# Service Bulletin

Bulletin No.: 25-NA-090

**Subject: Exhaust Leak Noise After Hard Acceleration**

6883456

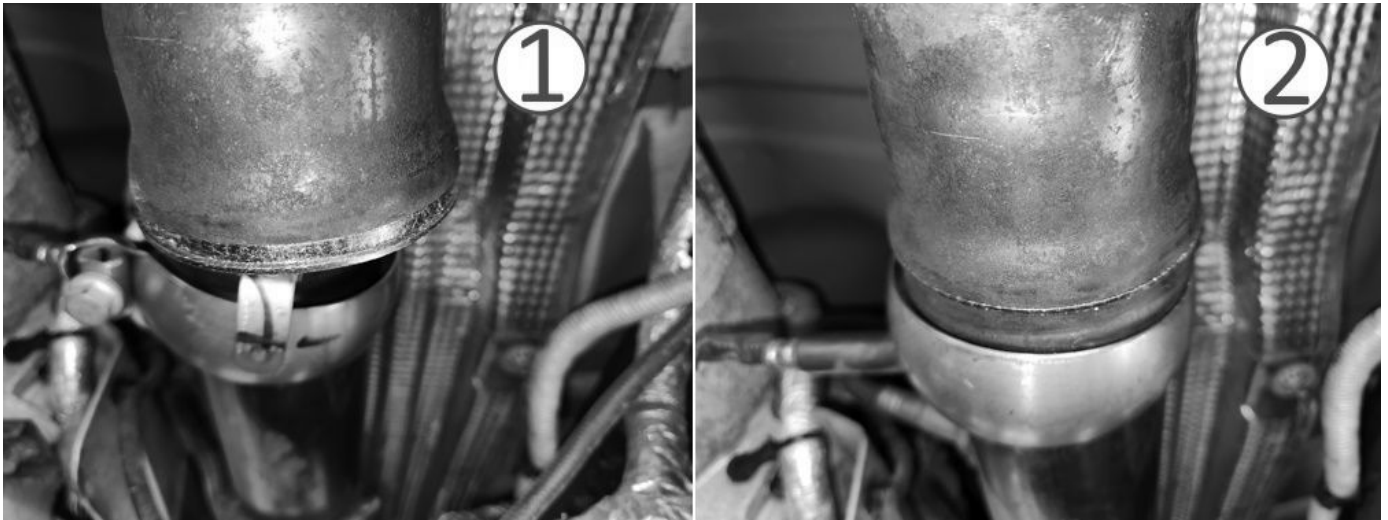
| <b>Cause</b>                      | This condition may be caused by a leak at the ball/flange of the connection of the exhaust system to the engine portion of the exhaust system.  |
| <b>Correction</b>                 | Add a graphite gasket to the clamped joint in the exhaust system.   |

3. Install the new graphite seal on to pipe (1) as shown in the graphic above.
4. Reconnect the pipe (2), verify for proper alignment.
5. Install the new clamp.
  - ⇒ Tighten clamp to 28 N•m (21 lb ft).
6. If any of the exhaust hangers were disconnected, re-secure them.
